MEMORANDUM

TO: Montgomery County Planning Board

SUBJECT: Snouffer School Road Improvements Phase I Transportation Facility
Planning Study
Project Prospectus Recommendations

Exhibit 2

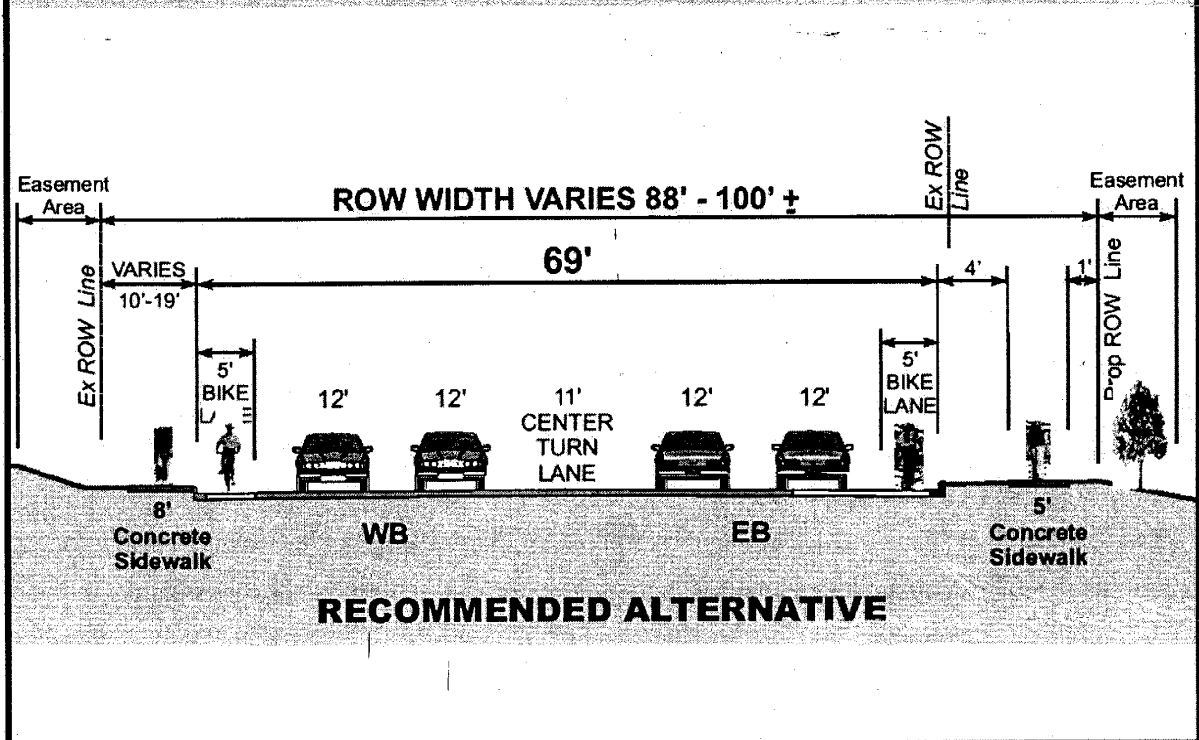
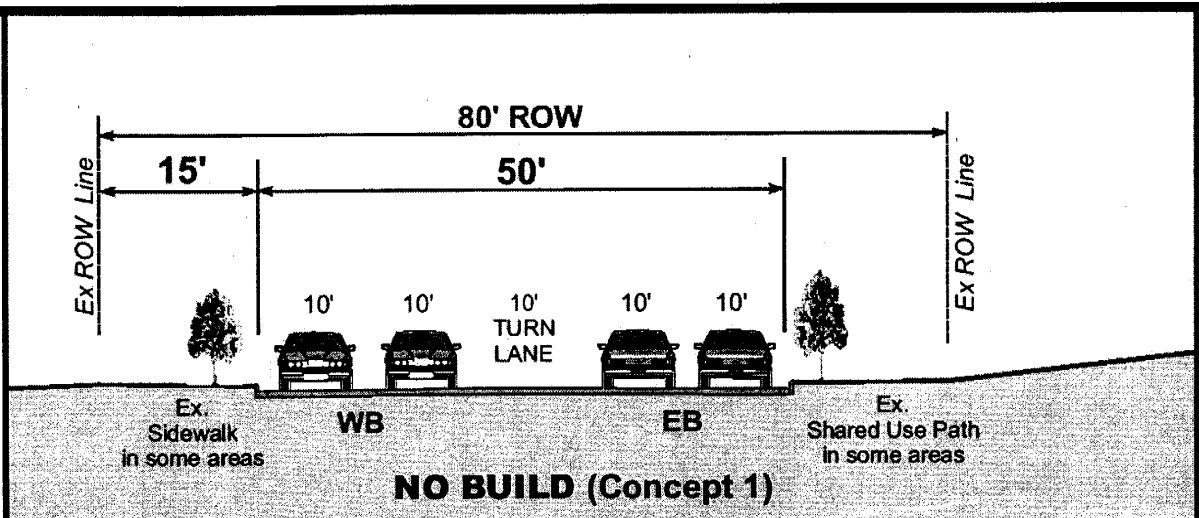
3. The Phase II Facility Planning study for Snouffer School Road should consider the following design details:
 - Pursue the application of Environmentally Sensitive Development (ESD) approaches for stormwater management, including innovative infiltration approaches.

- Further minimize or eliminate grading into the 100-year floodplain and part of the buffer of wetland S-2 west of Flower Hill Way.
 - Examine design and layout adjustments, where practicable, to save or minimize impact to large trees within the project limits.

- Develop a more detailed landscaping plan that incorporates opportunities for tree planting beyond the locations identified in the recommended typical section.

The typical section of the Recommended Alternative shows street trees located behind the proposed sidewalk in an easement along the south side of the roadway. On the north side of the roadway, street trees are not shown in the typical section due to impacts to immediately adjacent commercial businesses. The study reflects DPWT policy that closed-section roadways with speed limits 40 mph or greater cannot be designed with street trees placed in the green panel between the curb and sidewalk for the potential risk they pose to motorists, should motorists swerve off the roadway.

In general, staff continues to urge DPWT to adopt practices and policies on all projects more consistent with those applied by SHA that better integrate street trees into arterial and major highway typical sections. On this project, however, staff concurs with the typical section recommendation, as providing safe bicycle accommodation and minimizing right-of-way impacts to adjacent properties are higher priorities. During Phase II of facility planning staff recommends that DPWT develop a more detailed landscape plan that will identify additional opportunities for landscaping where available space permits.
